Committee Update Sheet – 29th November 2021

Vectos response to LCC Highways, National Highways, Network Rail and PROW

Modelling Results

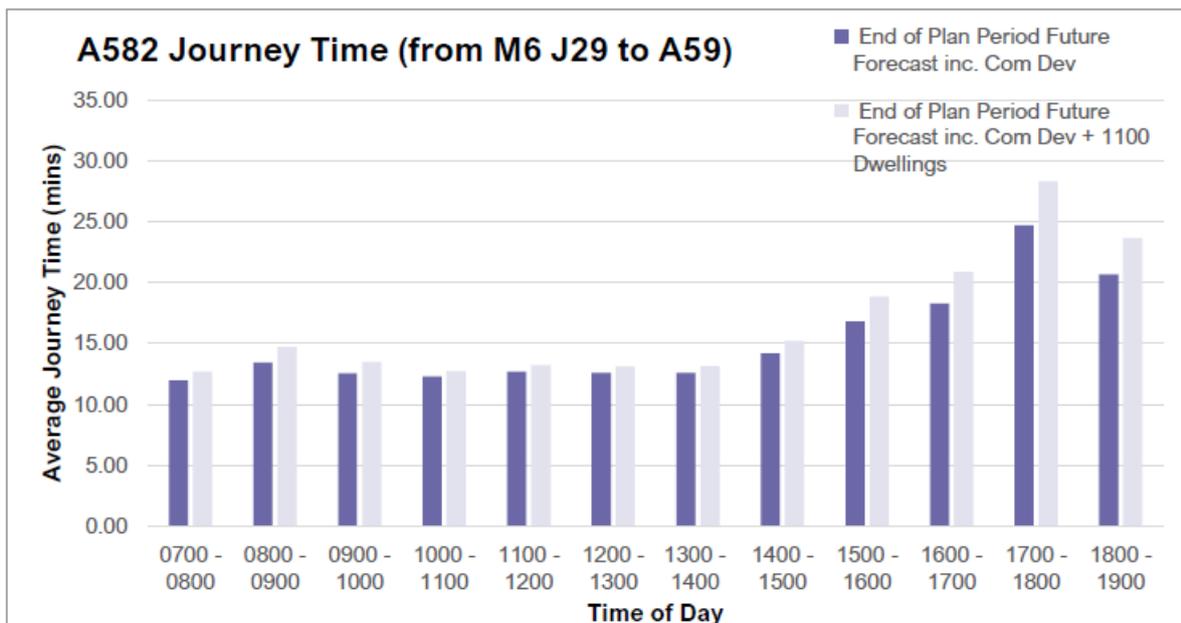
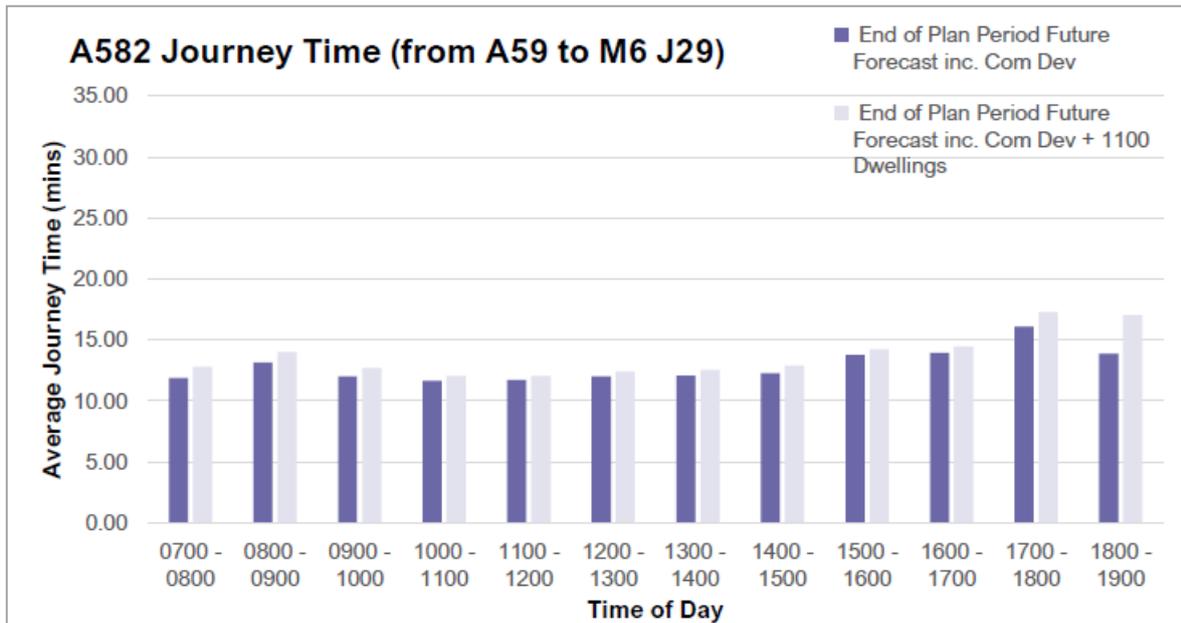
It has been noted by LCC Highways that the results of the modelling, due to what it considers a flawed modelling approach, are not accepted. Additional information has been requested regarding queue lengths on the network.

In LCC Highways' concluding remarks, it notes that there are several pinch points on the network where queueing extends for several hundred metres. This points to the fact that, in providing comments, the focus remains solely on the historic commuter peak period, and we note that a reasonable interpretation of policy is that it is not to protect the convenience of the car commuter. We expect that there will be pinch points on the network and that there will be queueing, some of which might increase at times of the day. However, the modelling which informs the TA makes forecasts of the everyday tangible metric of journey times which allows us to look at movement and the convenience of movement in the context of the whole day. A summary of average journey times per hour, for the through route along the A582 are included below.

The TA includes the key elements for review, and highlighted that further specific information can be made available on request. Given the request, additional model results for the scenarios presented in the TA are attached within Technical Note 03 – Traffic Data and Modelling.

These graphs show the mathematical results before making any judgements about a redistribution of unfettered demand either by time, mode or lifestyle change that would follow under a 'Vision and Validate' approach.

Convenience of vehicle movement across the day are relatively consistent in both directions with little variation. The variation is only evident for short periods and in the traditional commuter peak hours, in this case in the evening, when congestion and inconvenience increases. For the through route corridor between the A59 and the M6 Junction 29, a typical journey time southbound is in the order of 16-17 minutes without development, and 17-18 minutes with the development. For the northbound movement this is 24-25 minutes without development, and 28-29 minutes with the development. There is inevitably an increase in typical journey time as a result of accessing this allocated site from the A582 as it introduces a new signal-controlled junction to the network. When considering this in the context of journey purposes across the day, the NTS identifies that business trips (which are often viewed as contributing most to the overall economy) are most prevalent between 0900-1700hrs and less so in the times at which general convenience of travelling by road is least. Placing this in context, based on NTS data, business trips between 0700 and 1700, where convenience is broadly flat, makes up about 78% of daily business trips, and

business trips at the time where inconvenience peaks, although still at a low level between 1700 and 1900, makes up about 11% of daily business trips.
